Blackburn Creek
Community Development District

Marked Plan Set Documents of Inspected Curb Inlets and Manholes - Phase 3

APPENDIX A – MARKED PLAN SETS DOCUMENTS FOR MAINTENANCE WORK

Marked Plan Set Documents for Maintenance Work

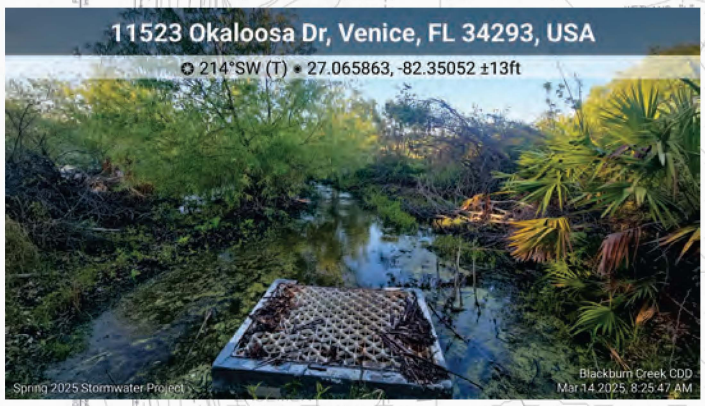
Clear out debris and vegetation from around CS; remove willow and other invasive around conveyance swale and CS

POND 12A
CWL=7.5
100YR=9.4±

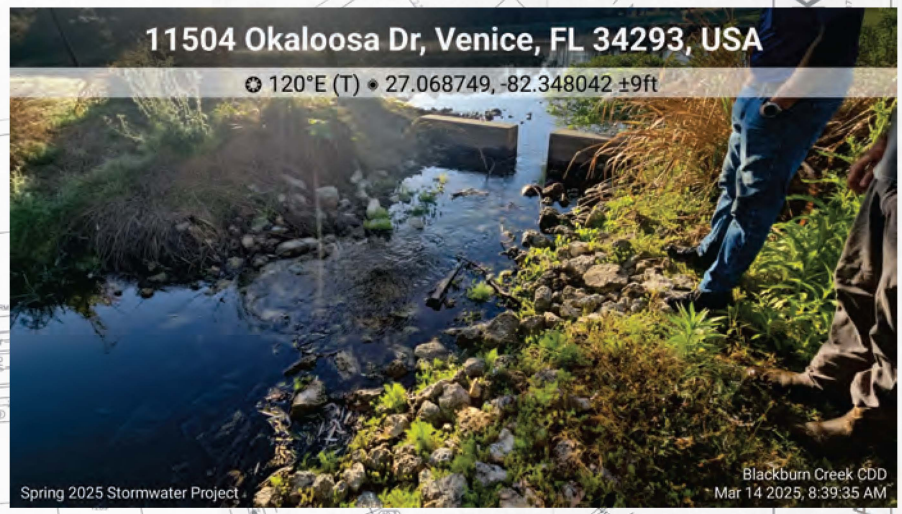
Water flowing into pond from wetland; Need to determine if weir is set to right elevation; Unpermitted structure over conveyance swale to wetland ditch

SHEET NUMBER
B-4B

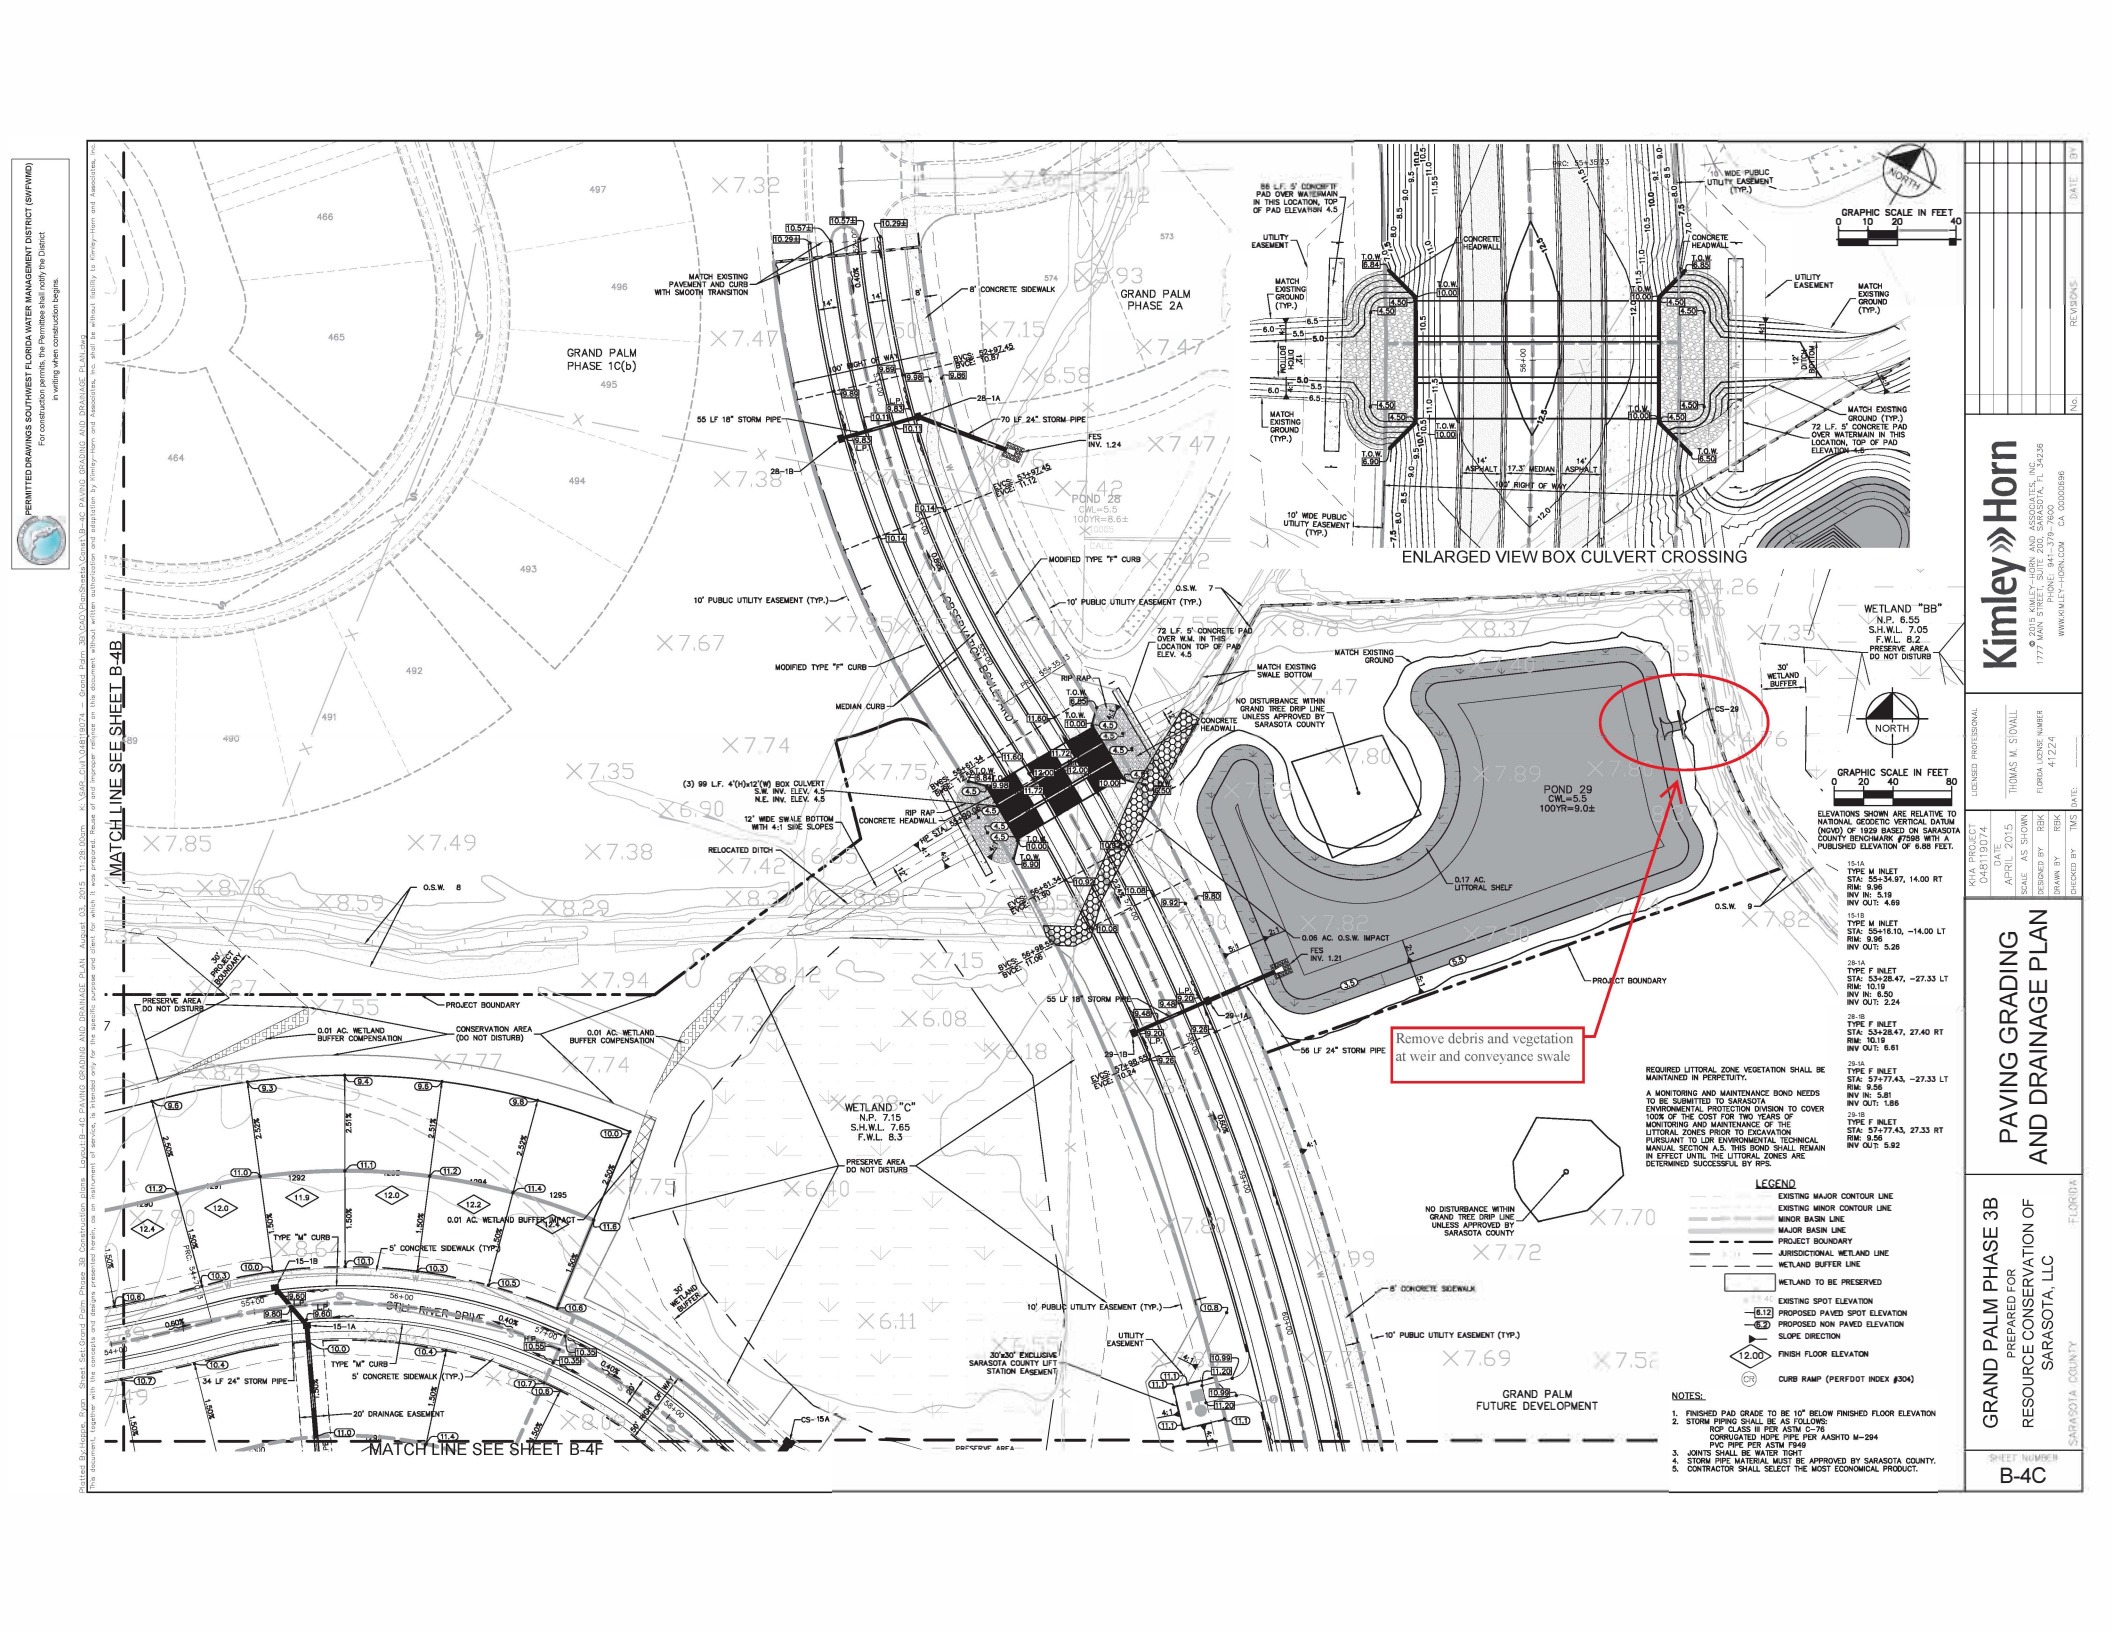
Clear debris and vegetation from structure and conveyance swale about 100ft into wetland; native vegetation to remain. remove invasive and nuisance

Remove nuisance and invasive vegetation and debris from structure and conveyance swale into wetland; about 100ft

Cut down vegetation and remove invasive and nusciance around structure and conveyance swale; remove sediment build up in swale and around structure

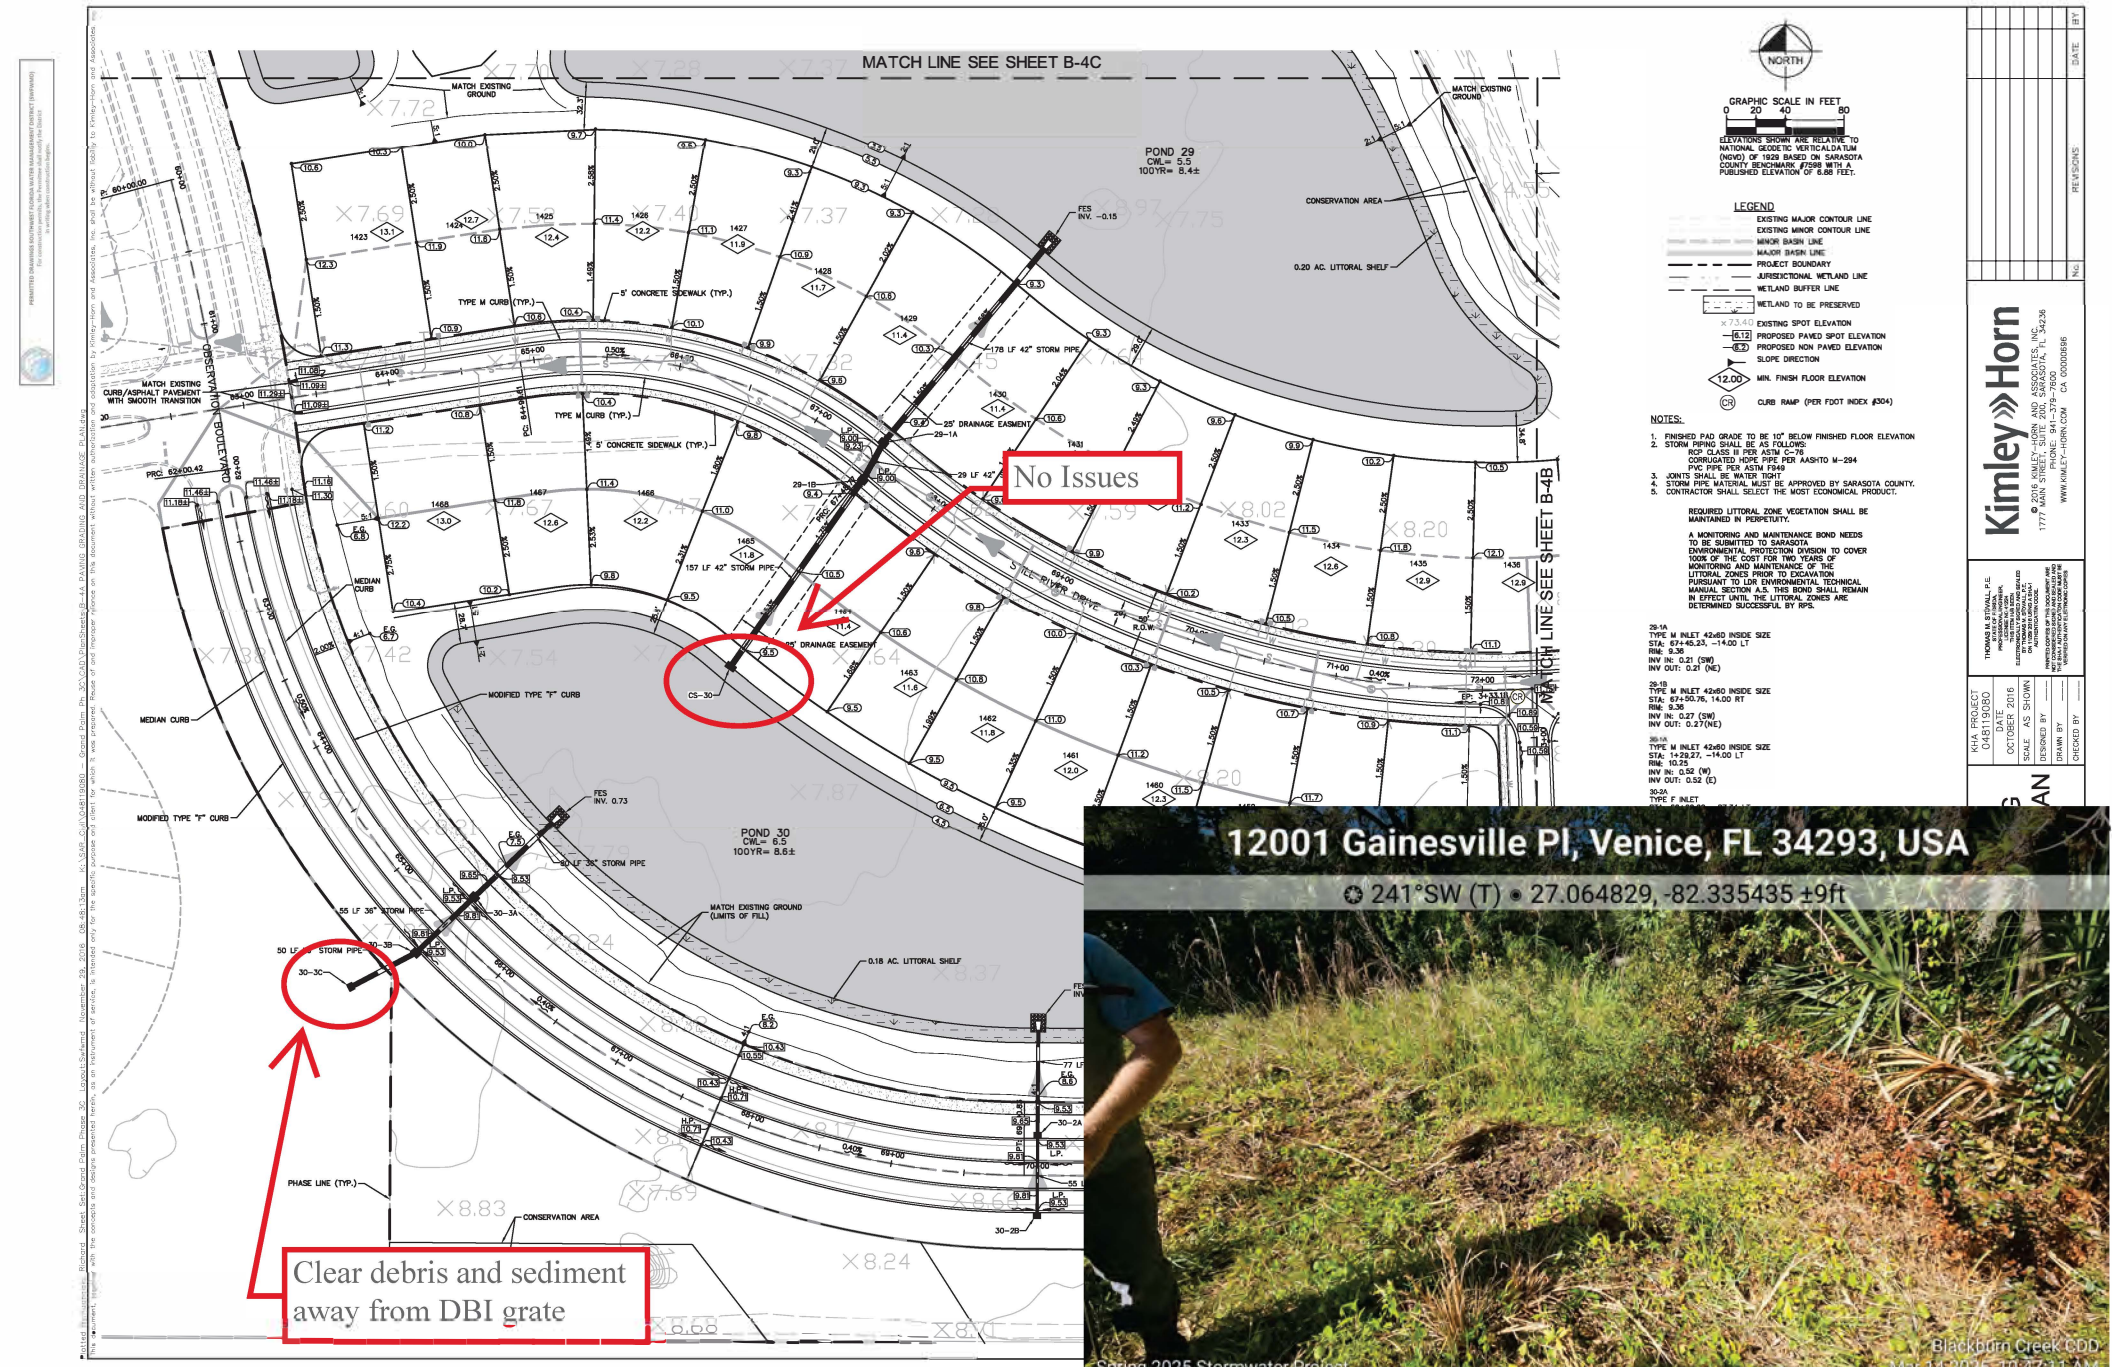
Pull grate out of CS and secure on top; cut new V bottom swales on either side of fallen tree to restore free flow of water

SHEET NUMBER
B-4B

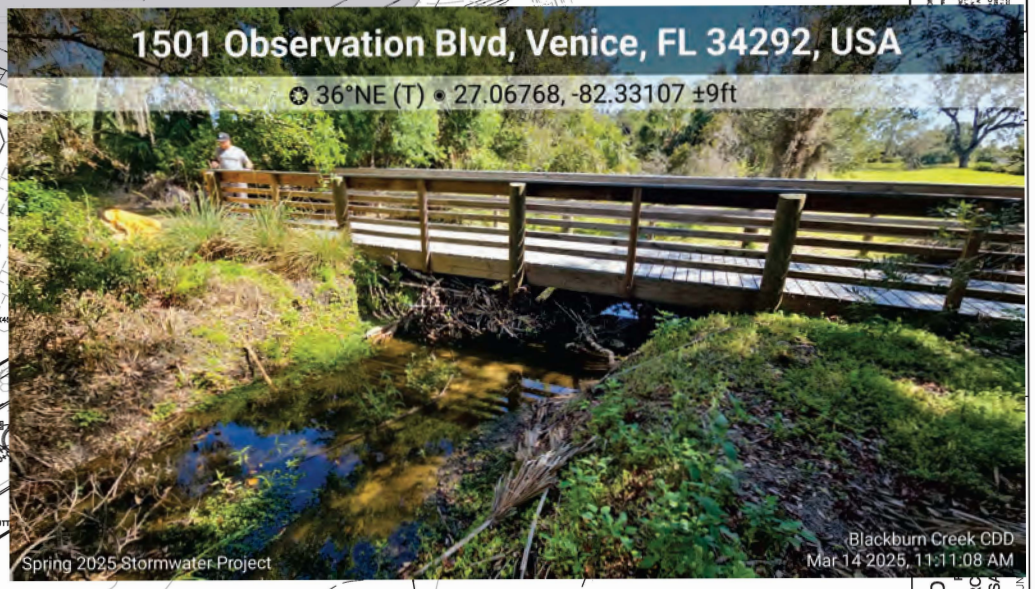
Clear debris in conveyance swale; clear debris from under bridge
